**RE: Murphy Express – Cottonwood
Conceptual Grading and Drainage Plan
Stamp Date: 8/23/17
Hydrology File: A14D003A**

Based upon the information provided in your submittal received 9/29/17, the Conceptual Grading and Drainage Plan **is not** approved for Site Plan for Building Permit. The following comments need to be addressed for approval of the above referenced project:

C-3

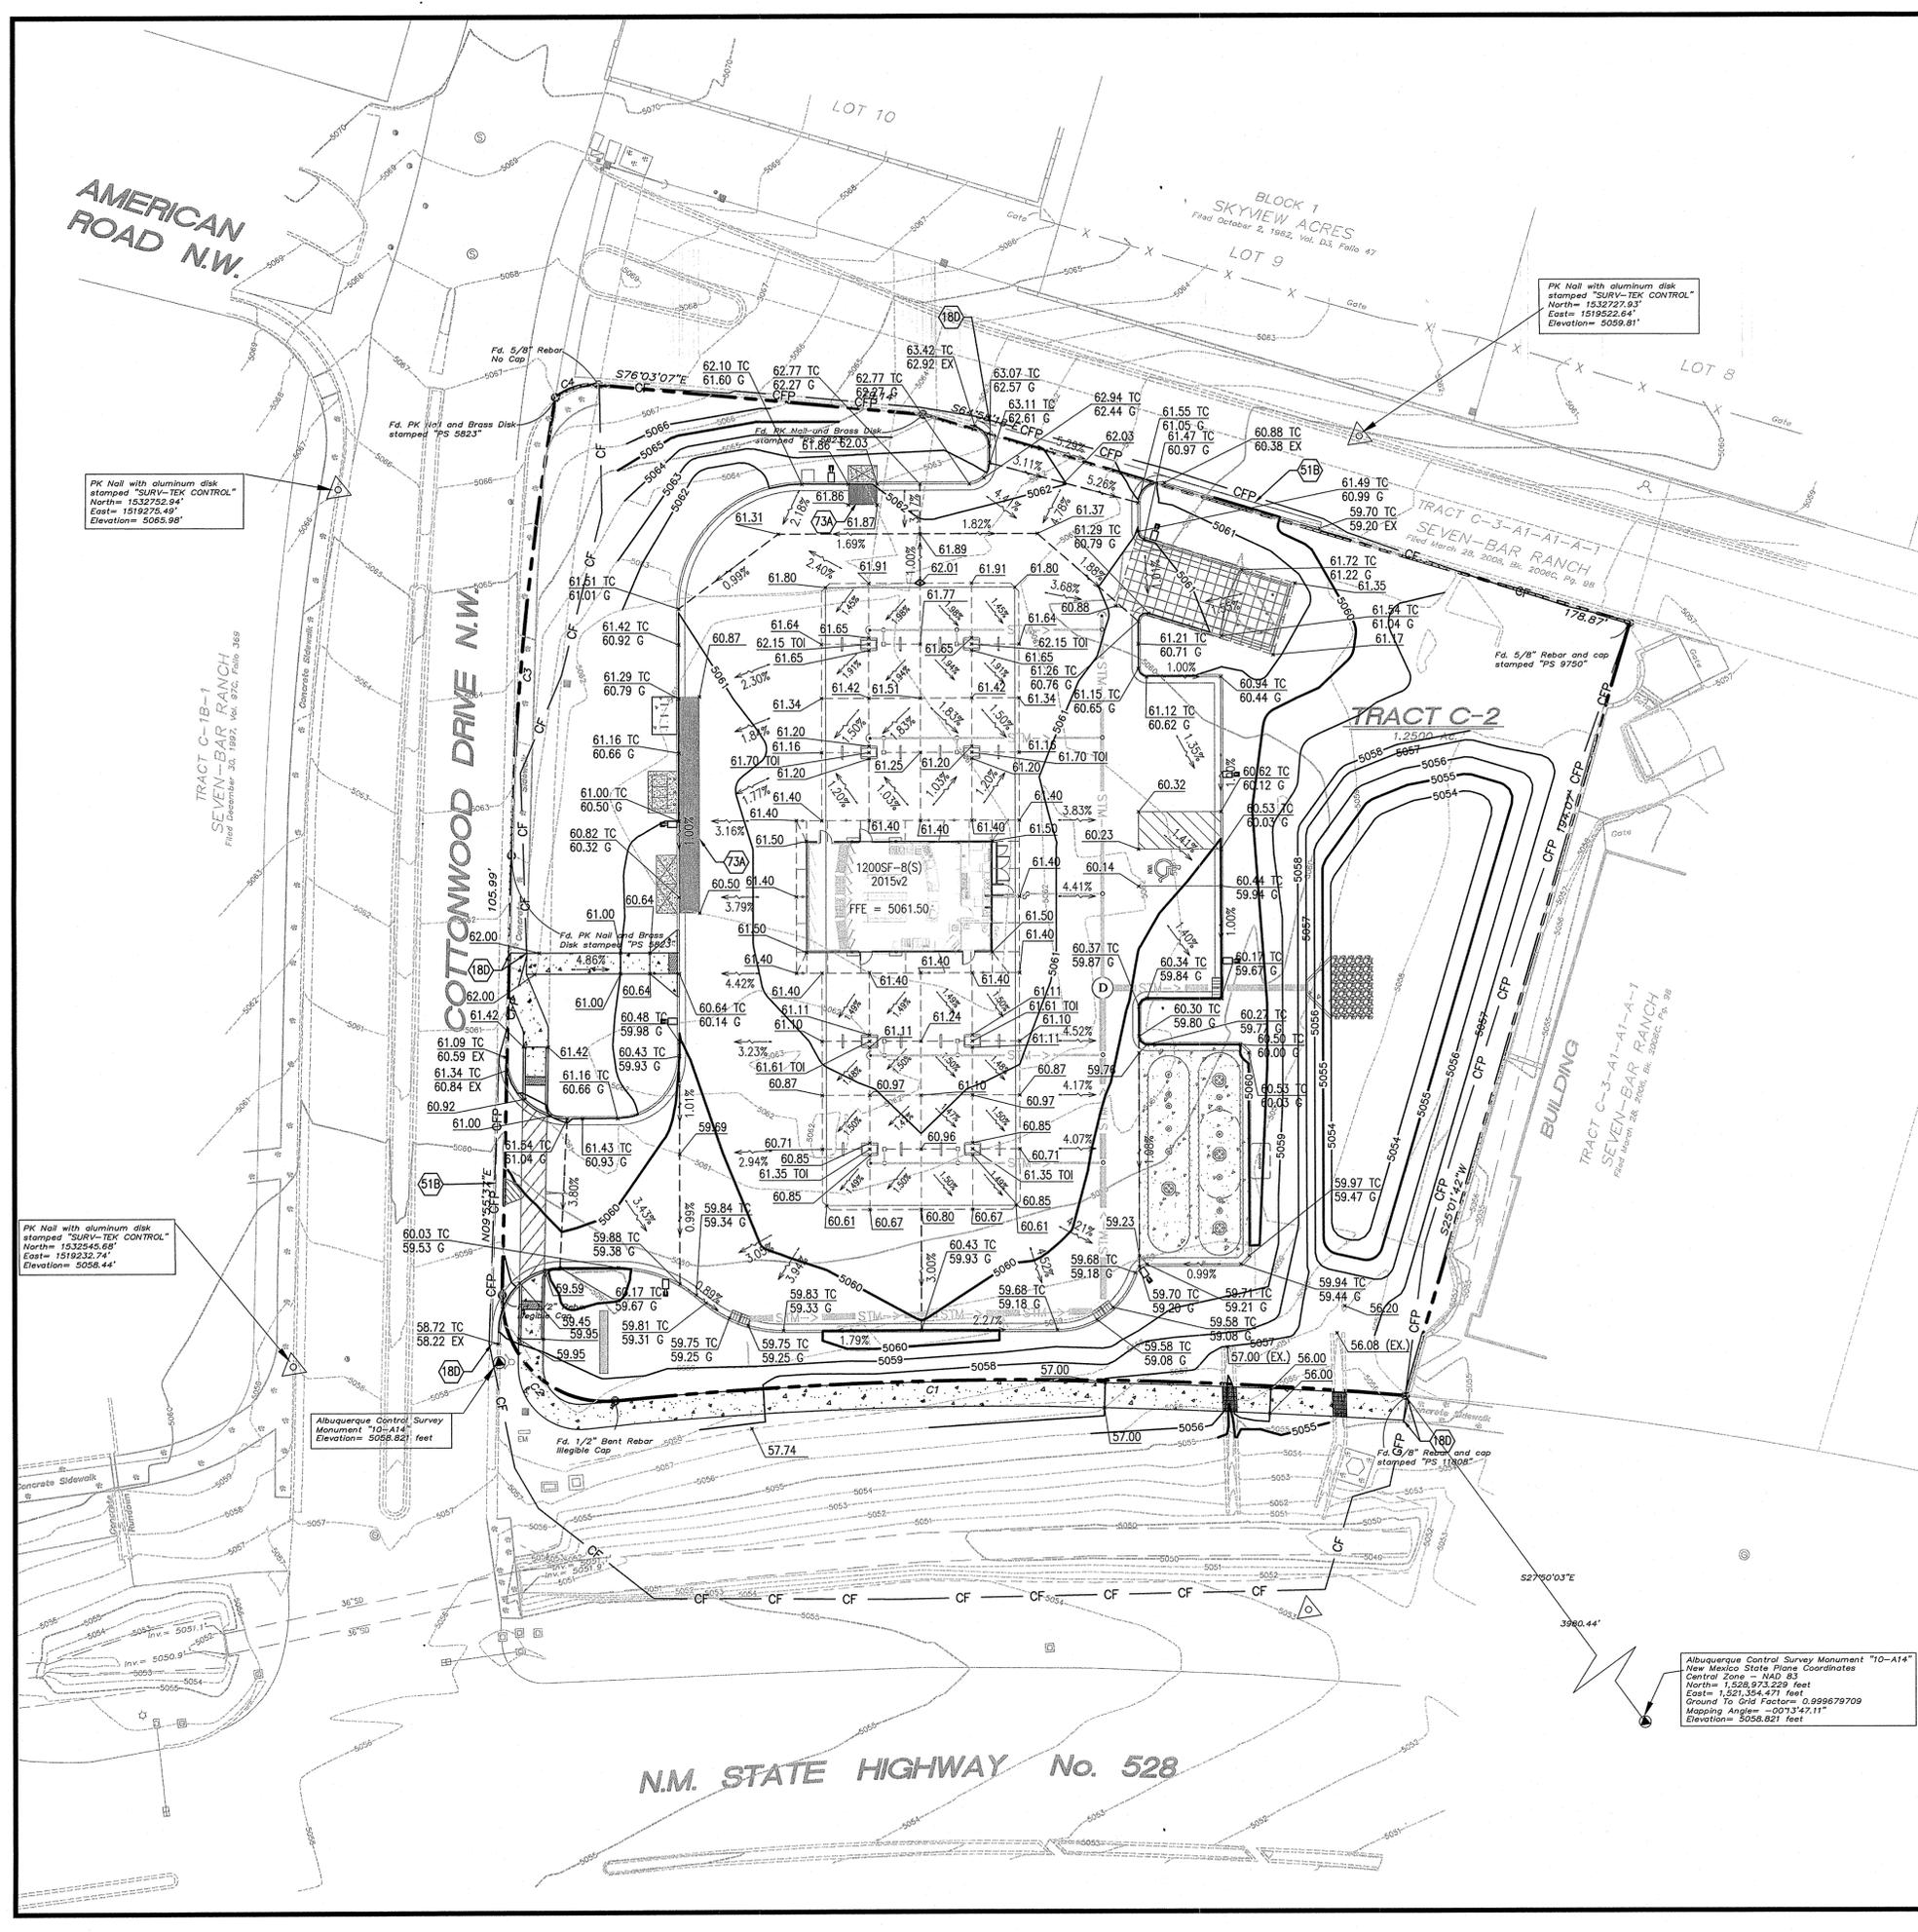
1. Sheet C-3. Please provide the flood plain note with effective date.
2. Sheet C-3 & C-3.1. Please add the word “Conceptual” to the sheets title and add a note stating “Not for Construction”.

3. Sheet C-3. Please use the procedure for 40 acre and smaller basins as outlined in Chapter 22, Part A of the Development Process Manual (DPM). Please provide both the existing conditions and proposed conditions for the 100 year-6 hour storm event.

4. Sheet C-3. Please add a note, “Prior to any work within Highway 528 Right-of-Way, a New Mexico Department of Transportation (NMDOT) permit will be required.”

5. Sheet C-3. Please add a note, “Prior to any work within Cottonwood Right-of-Way, a City of Albuquerque permit will be required.”
6. Sheet C-3.1. Please change the storm sewer manhole to an oil/water separator. Also provide a detail for the oil/water separator.

7. Sheet C-3. If the proposed pond is also to be a detention facility, then please use Chapter 22, Part A of the Development Process Manual (DPM). This section talks

how to use a hydrograph for small watersheds to calculate the volume needed for detention (100 year – 24 hour storm event). Please include the calculations. If a routing program is desired, then Chapter 22, Part C outlines a program called, “AHYMO”. Please do not use HydroCAD. This program does not exactly match the rain patterns here in Albuquerque.

8. Sheet C-3. Please show how the drainage is going from the proposed pond to the existing concrete channels.
9. Sheet C-3. Please provide wier calculations (Chapter 22 of the DPM) for the two existing concrete channels and state what the discharge rate of the site to the NMDOT’s drainage system.
10. Sheet C-3.1. Please reference City of Albuquerque standard detail No. 2236 – Sidewalk Culvert with Steel Plate Top at the two sidewalk culverts.
